GRADING AND EROSION CONTROL PLANS

THE COMMONS AT FALCON FIELD - FILING NO. 1

EPC FILE NO.: SF2435

ISSUE	DATE
INITIAL ISSUE	12/13/24
RESUBMITTAL	3/13/26
DESIGNED BY:	TDM
DRAWN BY:	GES
CHECKED BY:	TDM
FILE NAME:	21604-01ECCV

POND B PLAN VIEW
SCALE: 1"=30'

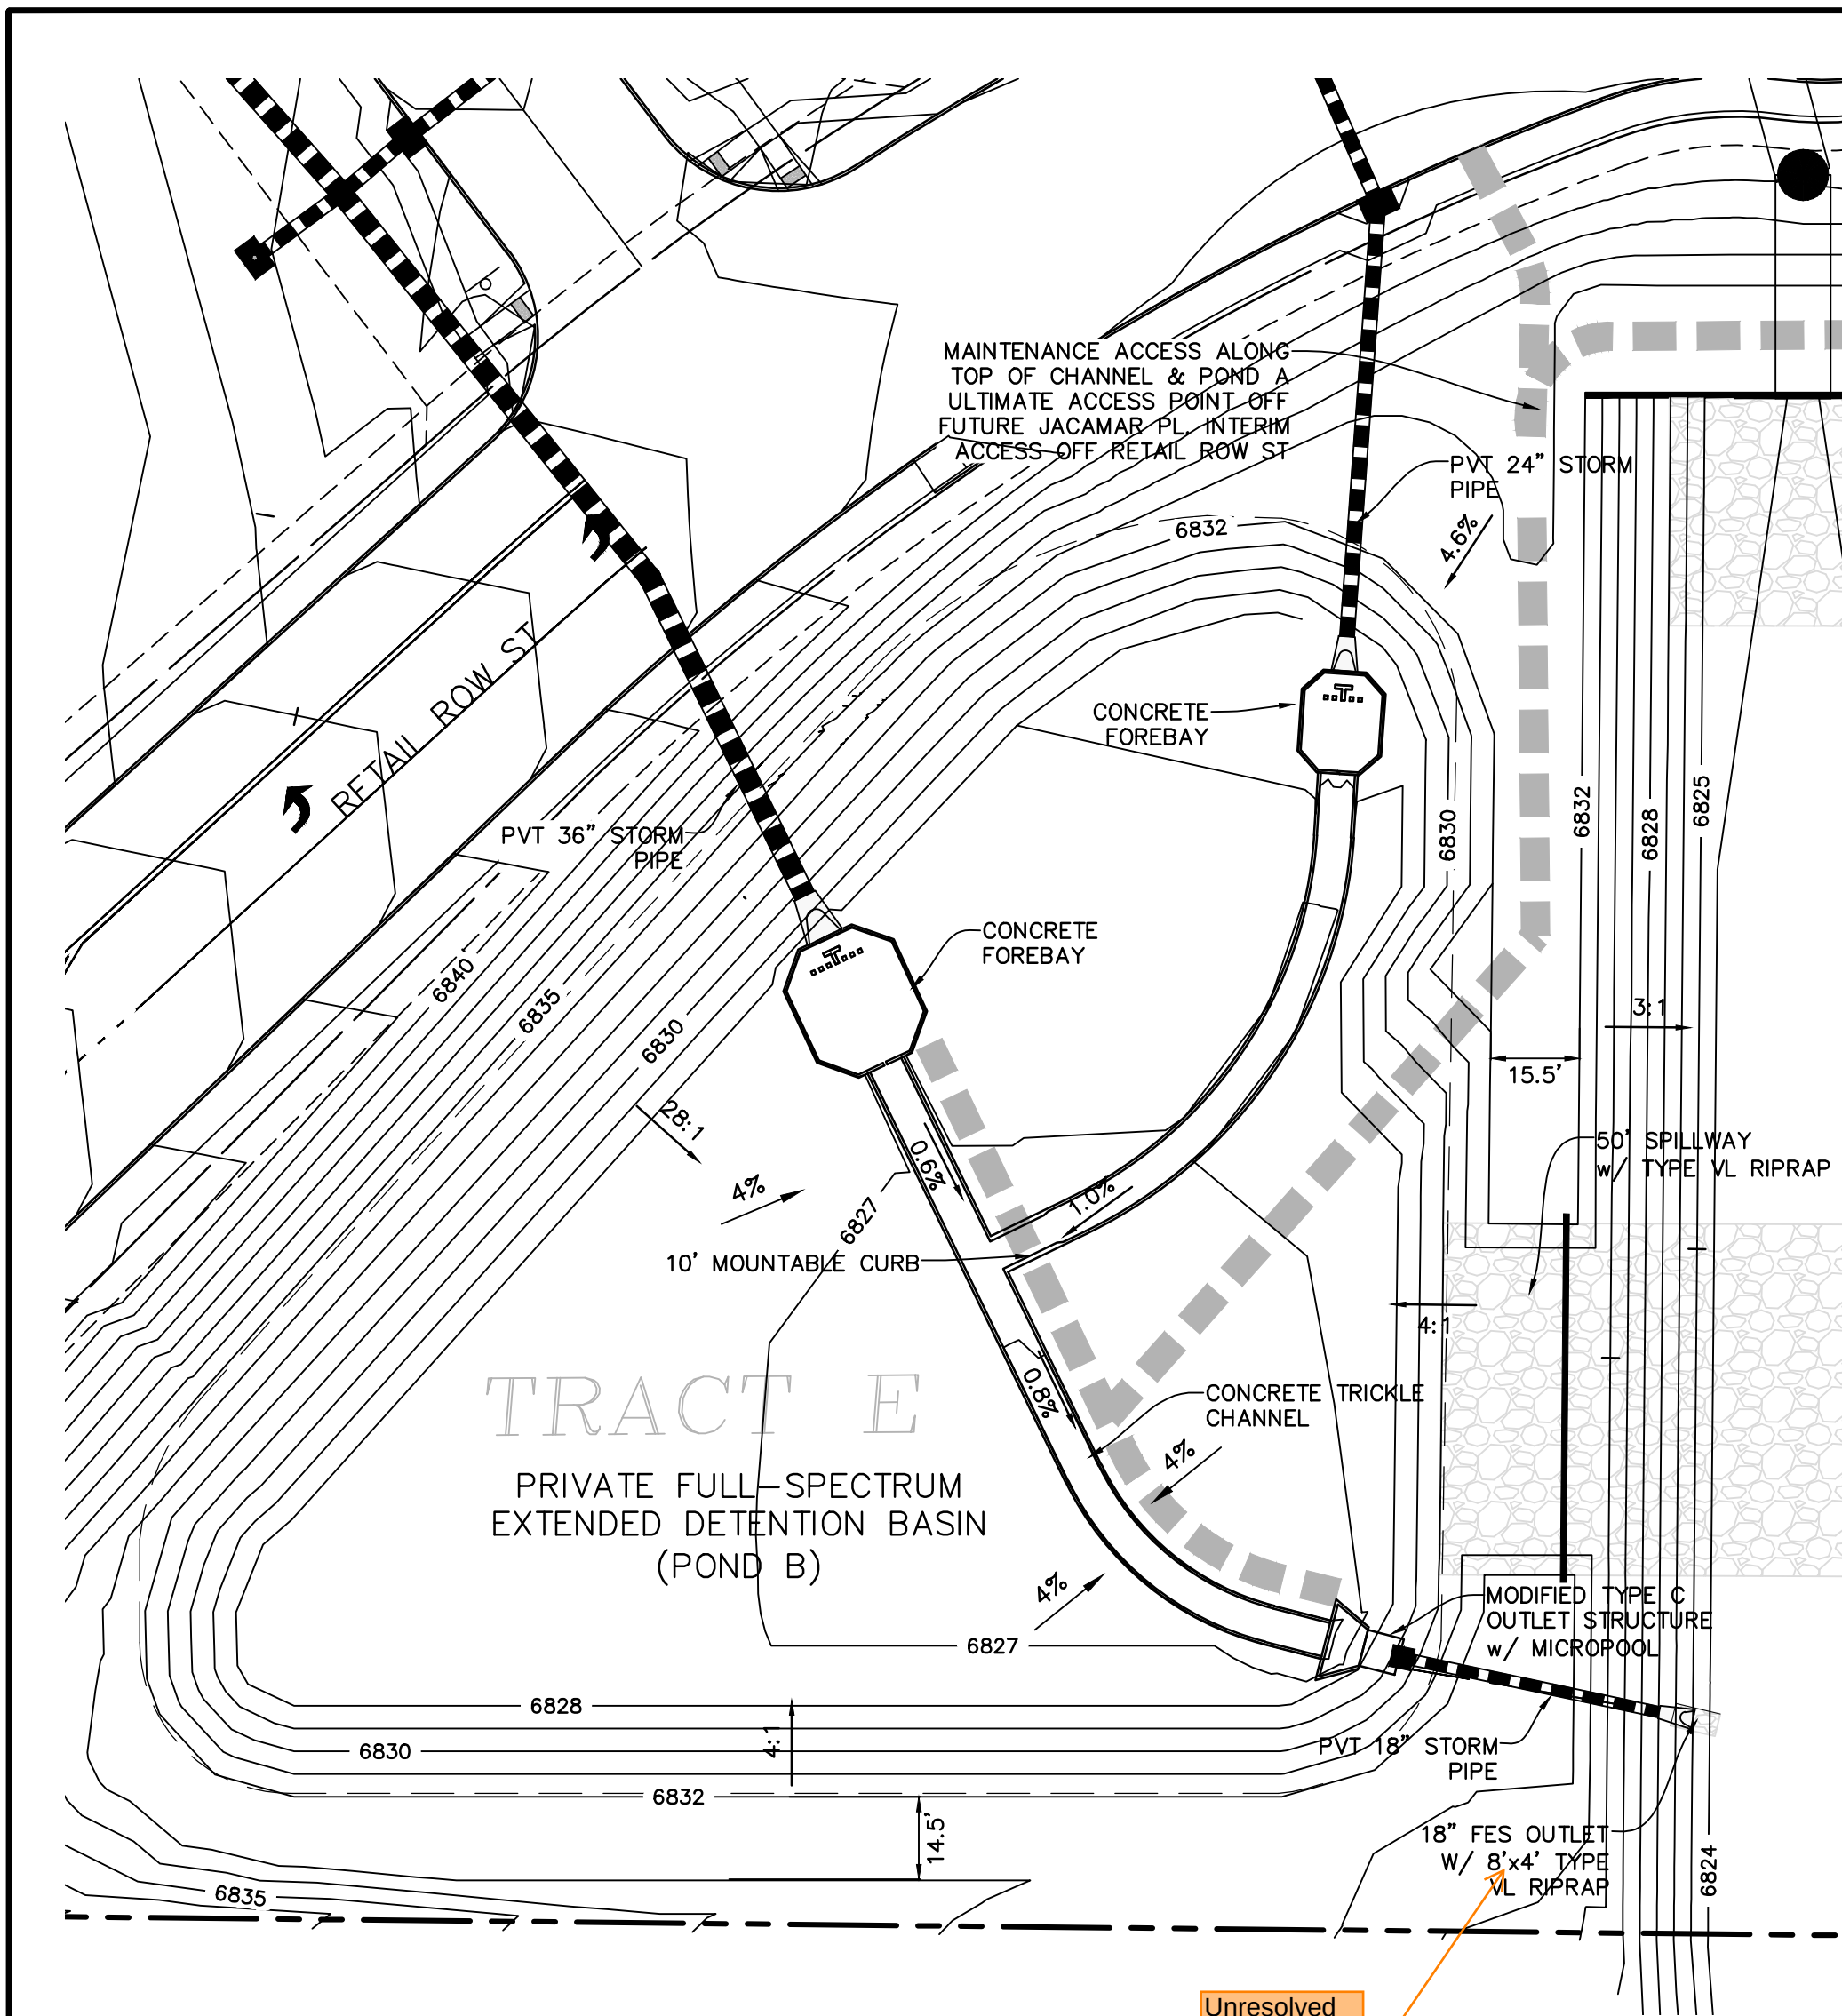
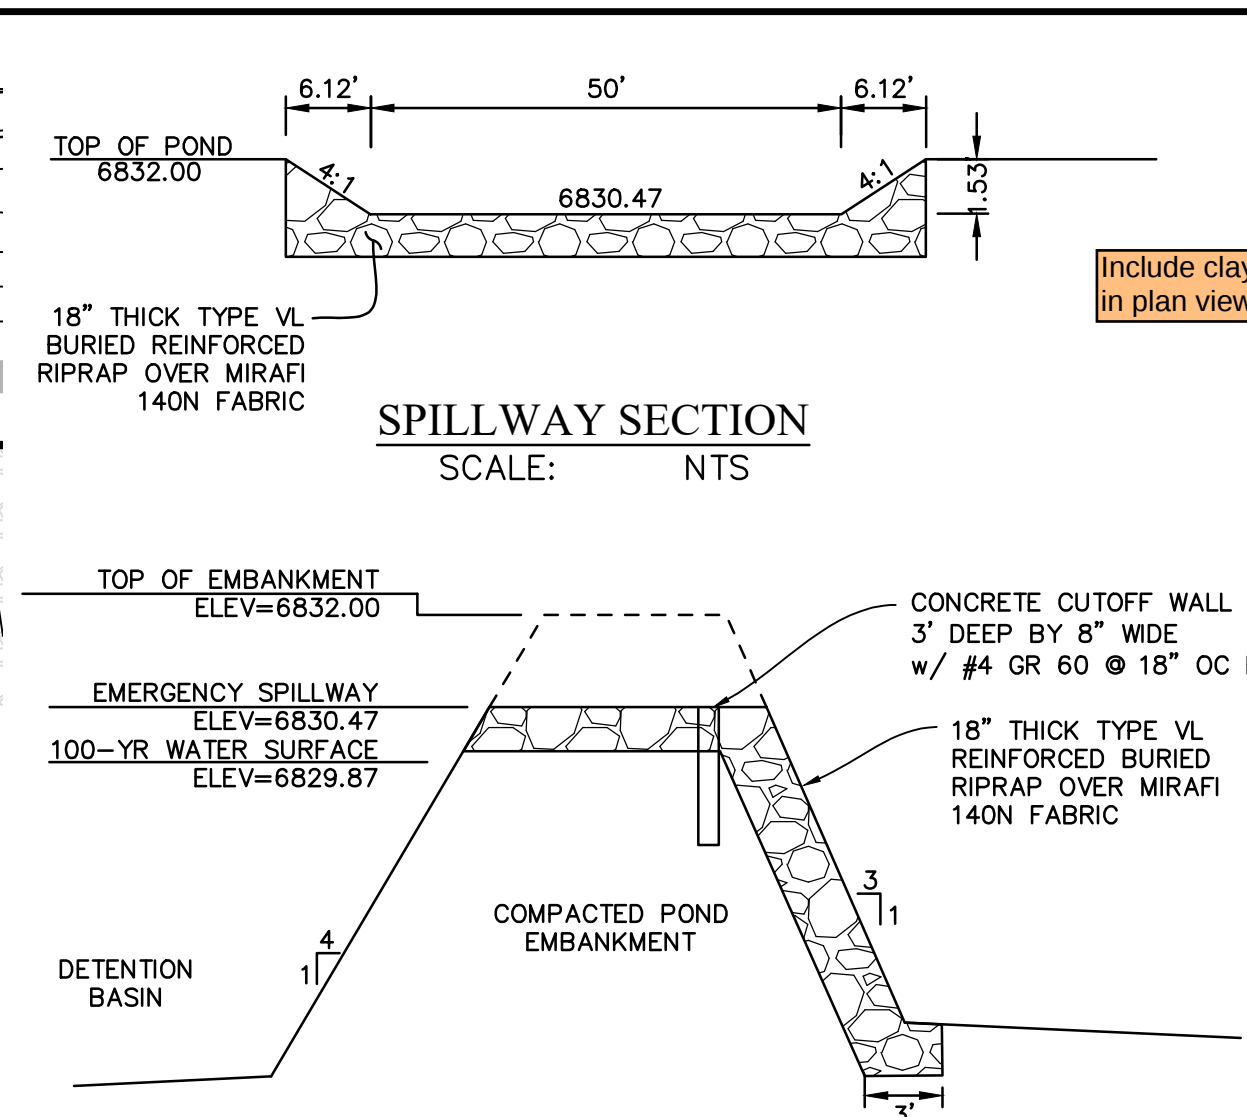
Please provide details for the incorporation of the clay liner at the proposed ponds as it is not certain the underdrain system will mitigate the ground water issues.

Include clay liner details for both ponds in plan view and the details.

SPILLWAY SECTION
SCALE: NTS

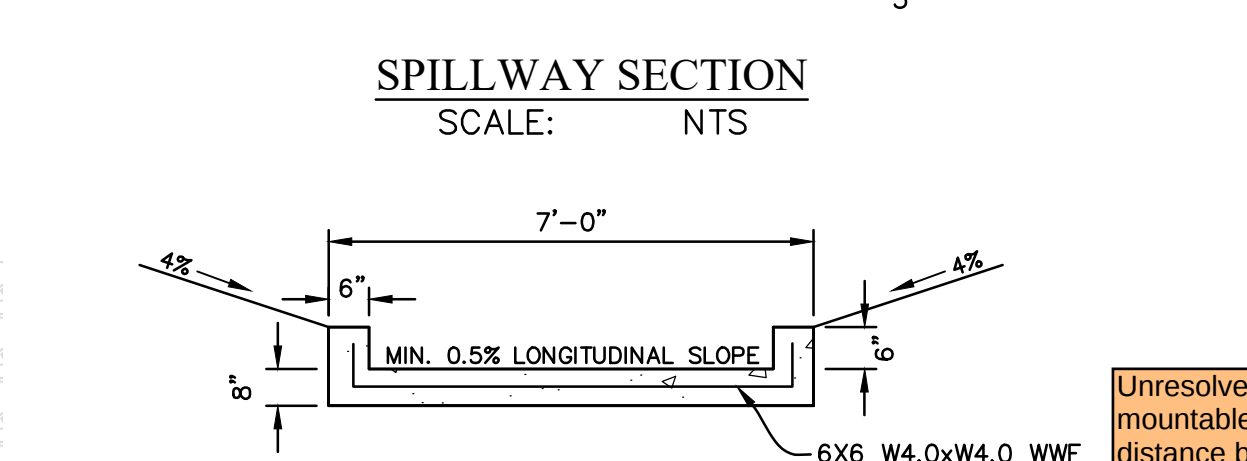
Unresolved include depth

ELEVATION TRASH RACK
SCALE: NTS

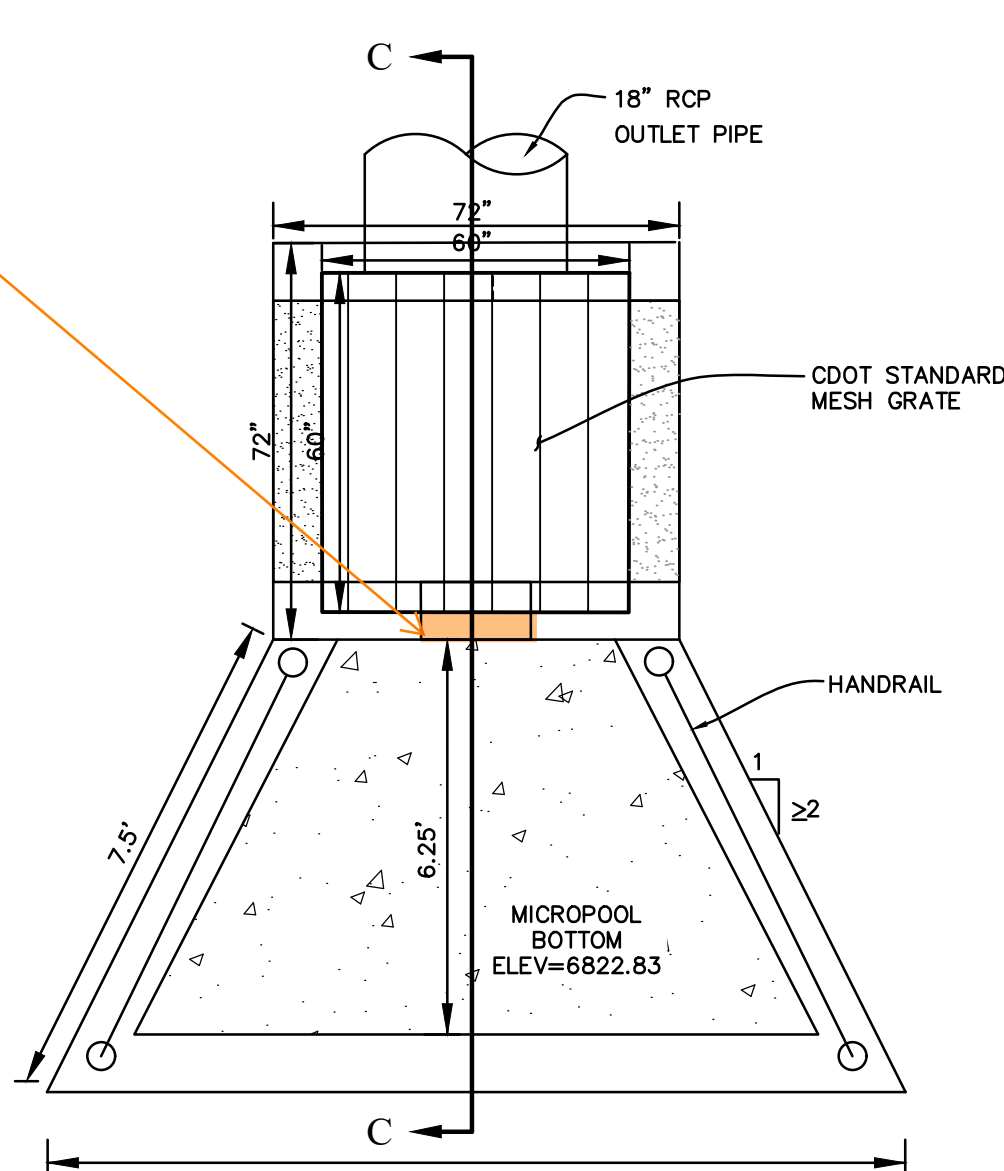
Unresolved: Clarify what will cover this opening, concrete? Steel plate? There shouldn't be an open gap at the top of the outlet structure
The grate will cover some of the opening but not all

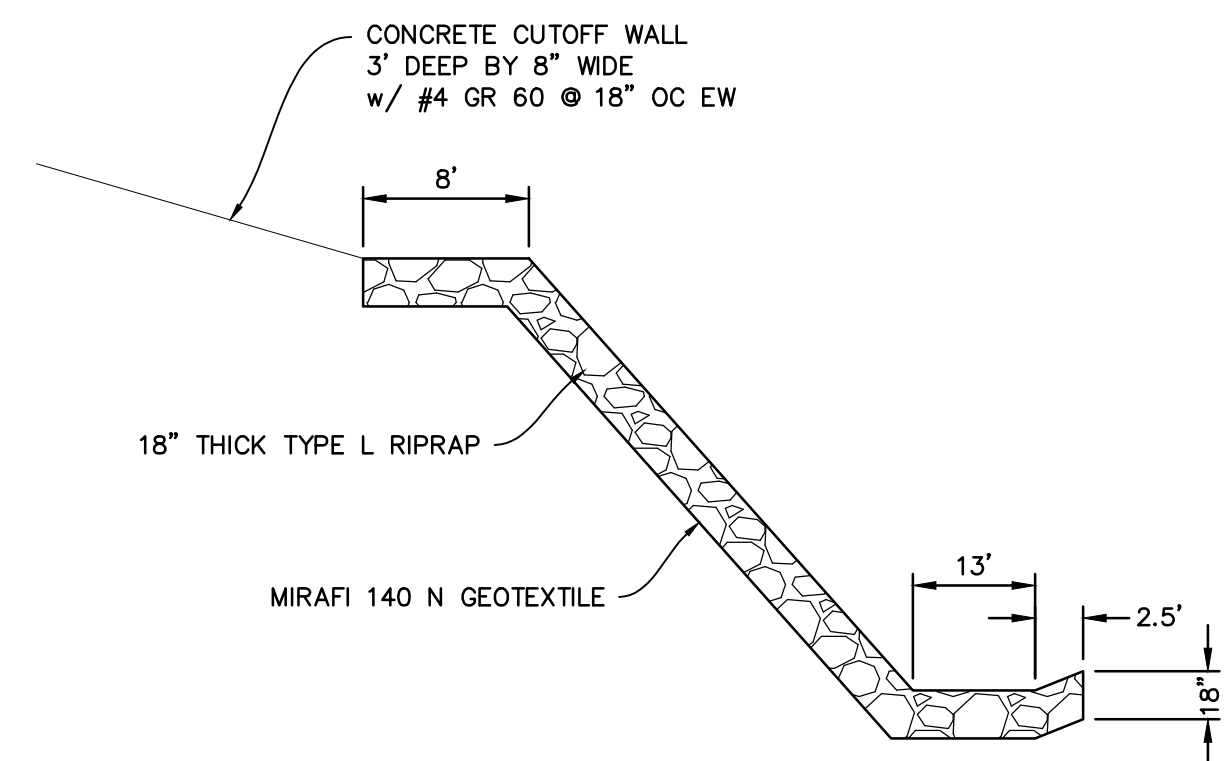
Unresolved: The TSB detail is for a 6\"/>
